ADDENDUM NO. 1

July 20, 2026

This Addendum is hereby made a part of the Contract Documents and modifies and takes precedence over the original Contract Documents dated July 7, 2026.

LEBANON COUNTY MUNICIPAL BUILDING
PHASE II RENOVATIONS
22-036

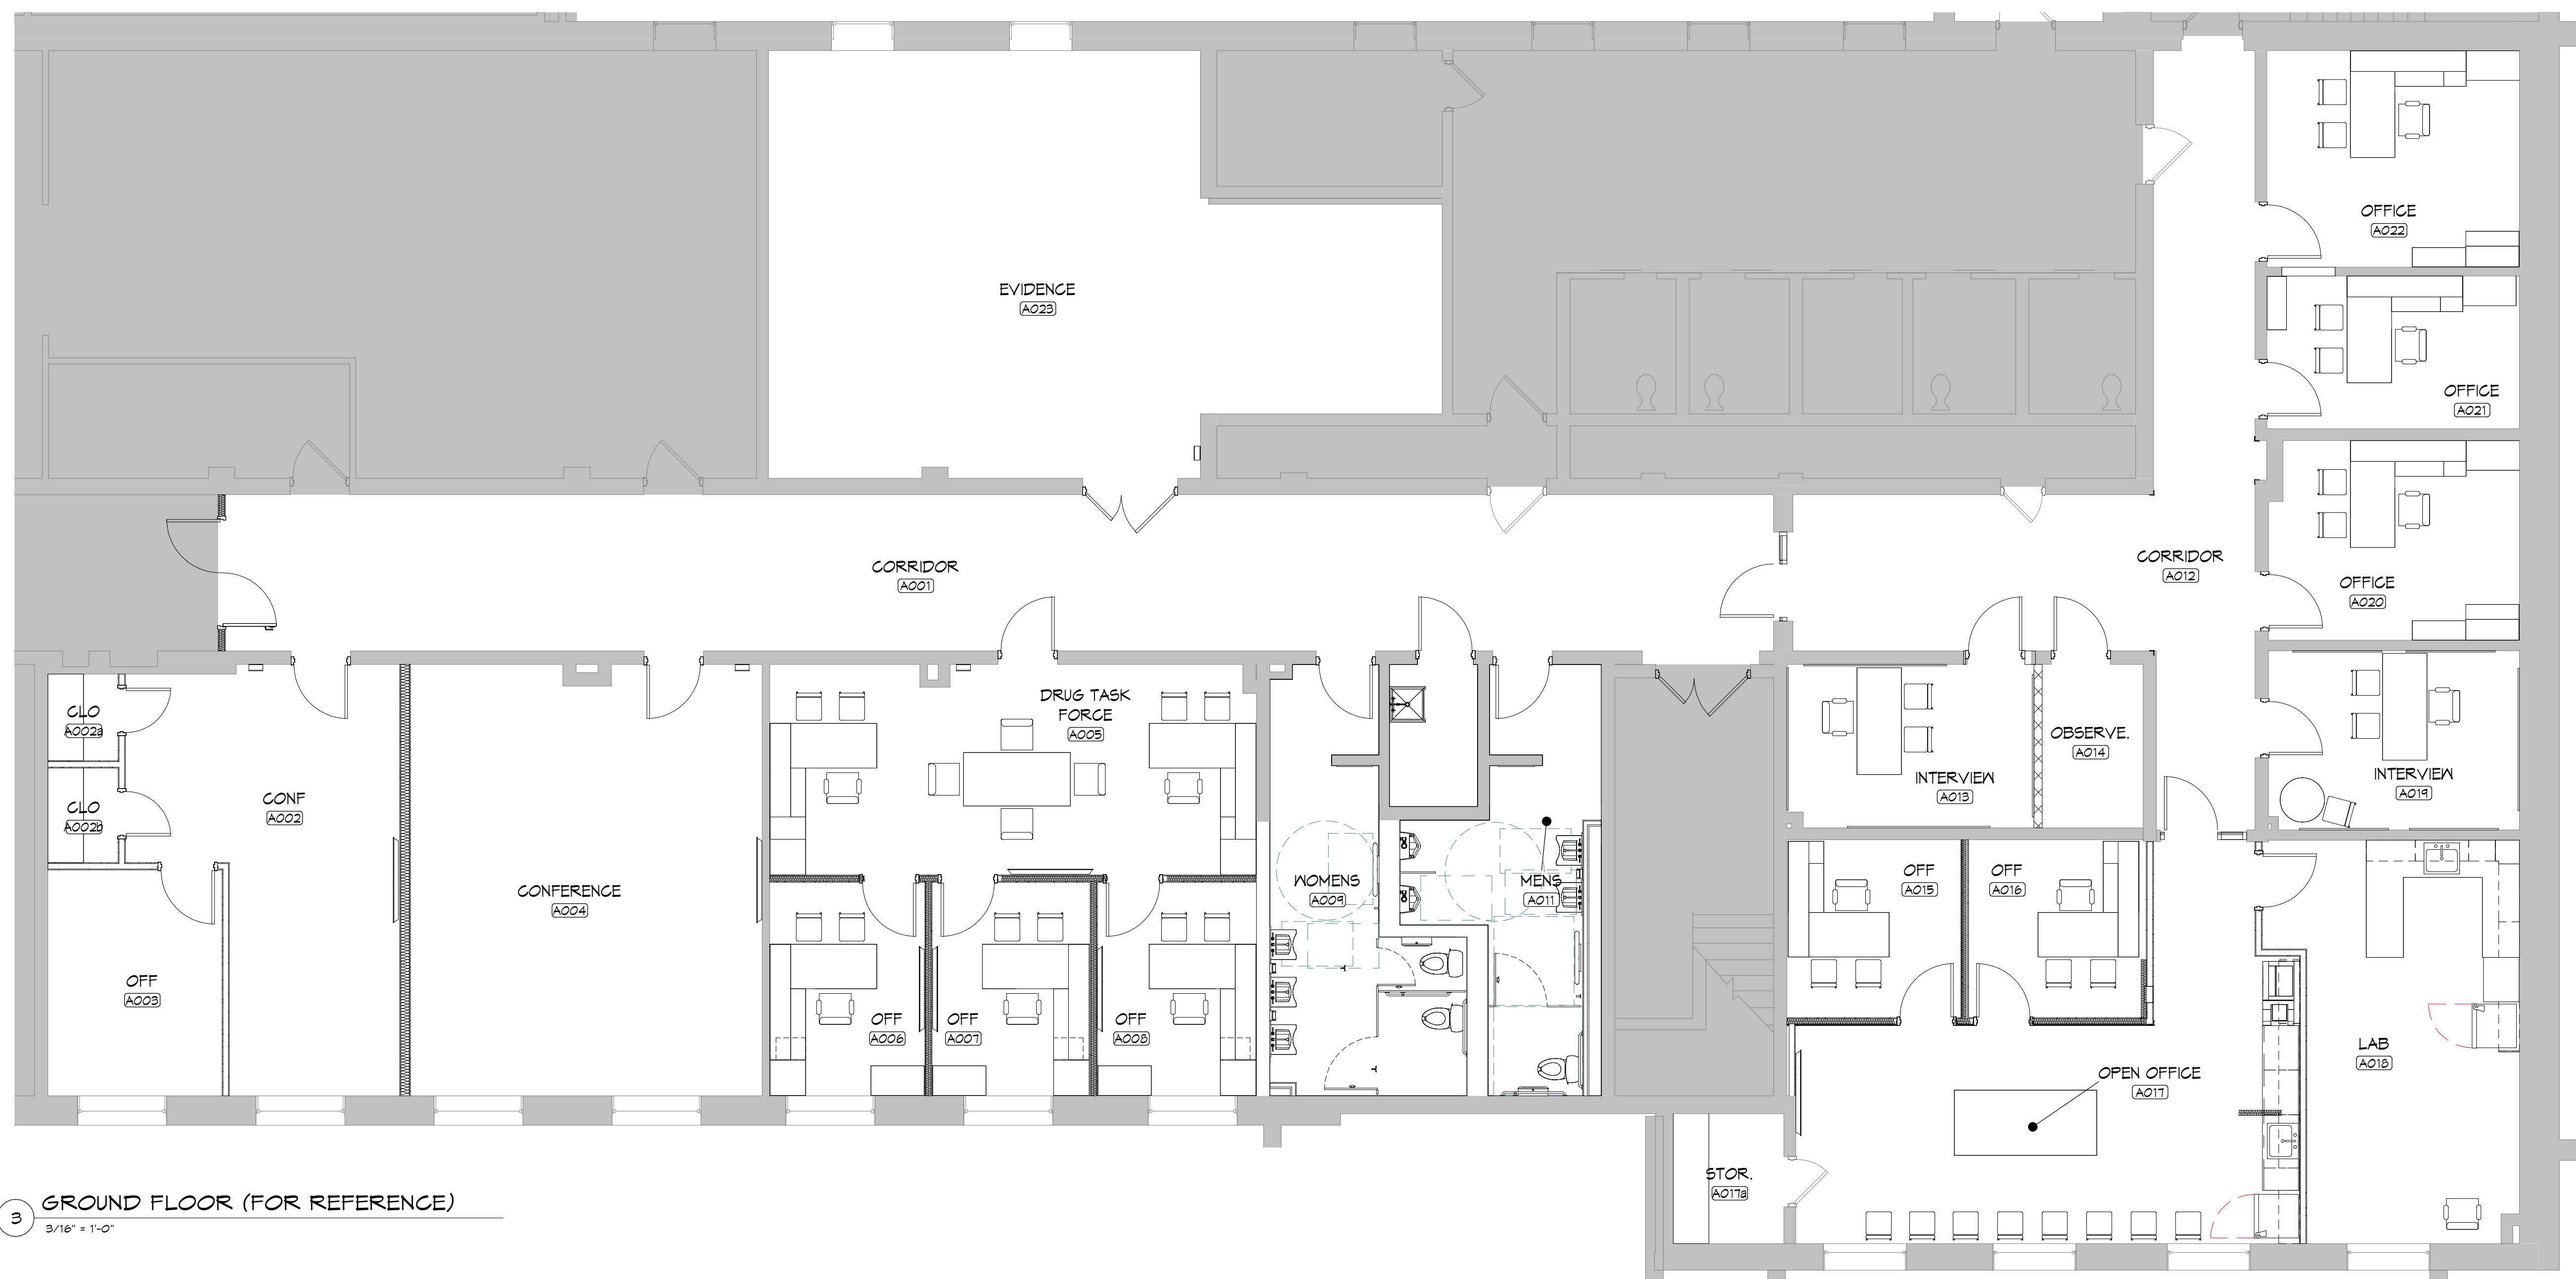
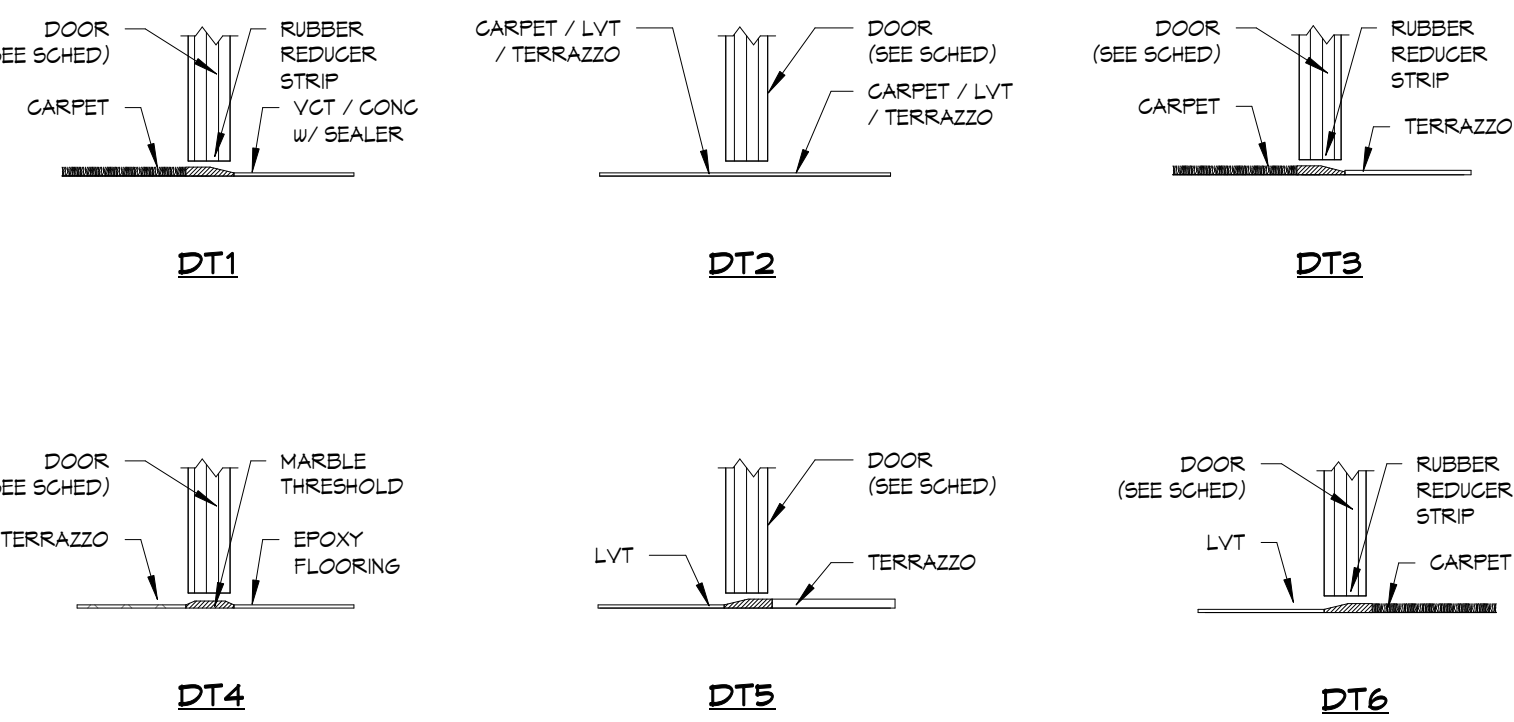
- a. REVISE Entire Door Schedule.
- b. REVISE SF3 Tag.
